To: Complaints Department
London Borough of Croydon
Bernard Weatherill House
8 Mint Walk
Croydon
CR0 1EA

From: Monks Orchard Residents' Association
Planning

28th March 2019

Planning Committee 21st March 2019: Application Ref: 18/06070/FUL – 9a Orchard Rise, Shirley, CR0 7QZ

Figure 2.29e: Requirements for entrances and boundary treatments.

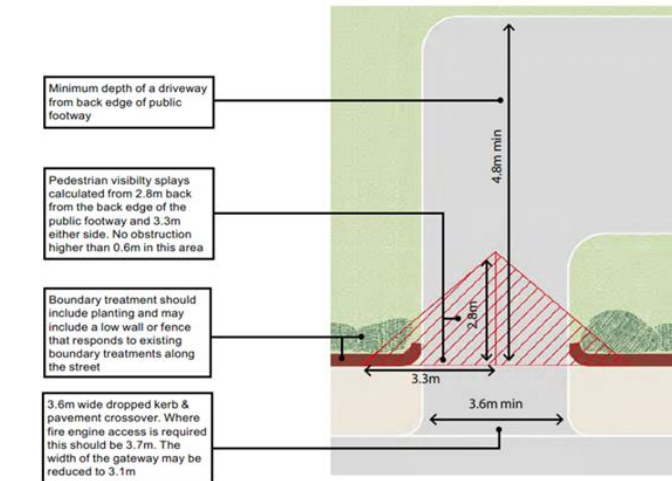
We do not think the illustration at SPD2 fig 2.29e & fig 2.29.f (see above) has been modified for the final draft copy to be presented to Cabinet on 25th March 2019.

It should be noted that the Supplementary Planning Guidance (SPD2) at fig 2.29e requires the minimum width to be **3.6m** when the **actual measured width** for this application is **3.1m**. but that **Table 8** above requires a minimum **kerb to kerb distance of 3.7m**. (this passageway has no kerbs to guide vehicles if drifting too far either side and damaging fencing! If kerbs were to be installed that would reduce the width to even less than 3m).
